COUNCIL ASSESSMENT REPORT

Panel Reference	PPSSNH-424
DA Number	DA-2023/237
LGA	Willoughby City Council
Proposed Development	Demolition of existing structures and construction of a 27- storey mixed use development with a 3-level basement, associated site landscaping and public domain works. The building consists of a 2 storey podium with retail/commercial floor space at the ground and first floor levels, and two residential apartment towers above comprising 193 apartments and communal facilities. The application is identified as nominated integrated development requiring approval from Water NSW pursuant to s90 of the Water Management Act 2000.
Street Address	9-11 Nelson Street, CHATSWOOD NSW 2067
Applicant/Owner	Andrew Hobbs (Urbis)/ 9-11 Nelson St Pty Ltd
Date of DA lodgement	05 September 2023
Number of Submissions	5 submissions (including one letter of support)
Recommendation	Refusal
Regional Development Criteria (Schedule 6 of the SEPP (Planning System) 2021	Schedule 6 of the SEPP (Planning Systems) 2021: CIV > \$30M

SNPP NO: PPSSNH-424
COUNCIL: WILLOUGHBY CITY COUNCIL
ADDRESS: 9-11 NELSON STREET, CHATSWOOD NSW 2067.
DA NO: DA-2023/237
PROPOSAL: INTEGRATED DEVELOPMENT - DEMOLIT

Extract of Level 2 plan showing public access easement location along the eastern boundary.

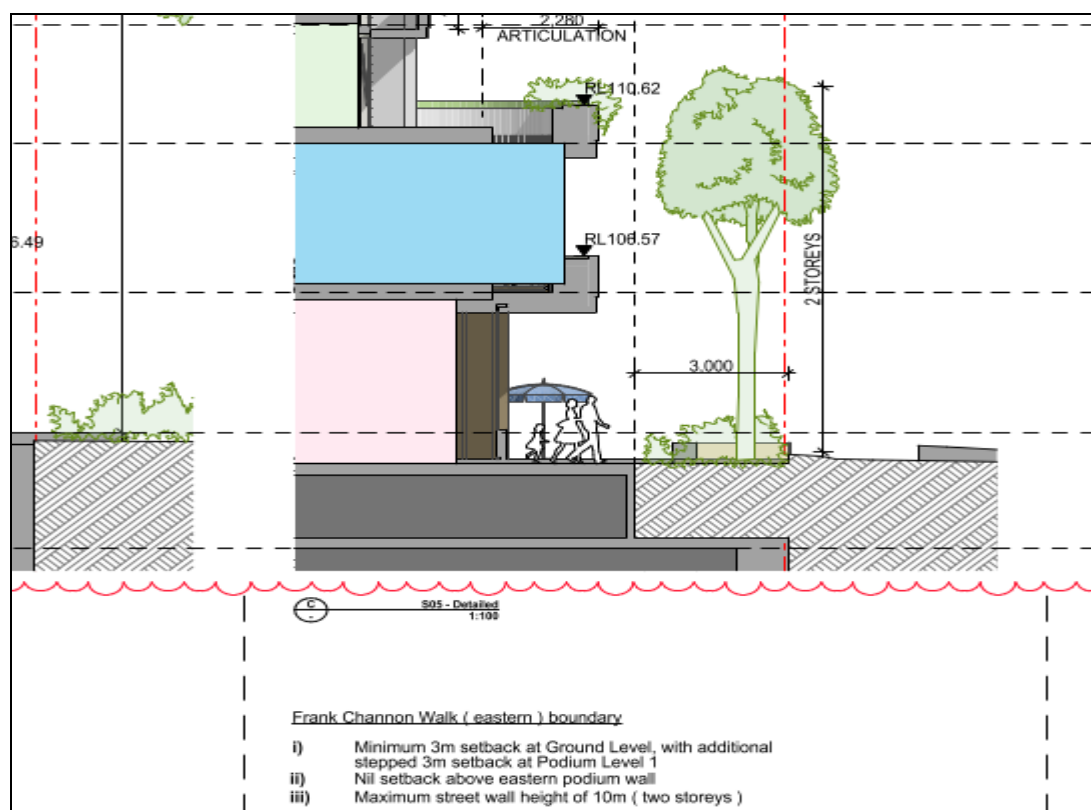
- **Public Access easement (inconsistency)**

The site-specific DCP requires a 3m wide public access easement along the eastern boundary, intended to provide unimpeded public access through this area. While the applicant has acknowledged the rights of way, an issue has been identified with the proposed public access along the eastern boundary.

Although all podium-level structures are set back from this area, the space is obstructed by steps, large planter boxes containing trees, and bicycle parking, rendering it unsuitable for its intended access function. While the required width is nominally provided, the design fails to deliver a usable space for pedestrian movement. As illustrated in the extract below, the majority of the right of way is occupied by a planter box, significantly limiting pedestrian access.

Moreover, the applicant has not demonstrated that the right of way is accessible to all potential users, including people using wheelchairs. Additionally, the proposal does not comply with the provisions of the executed Voluntary Planning Agreement (VPA), particularly Schedules 5 and 6, which in line with the WDCP requirement.
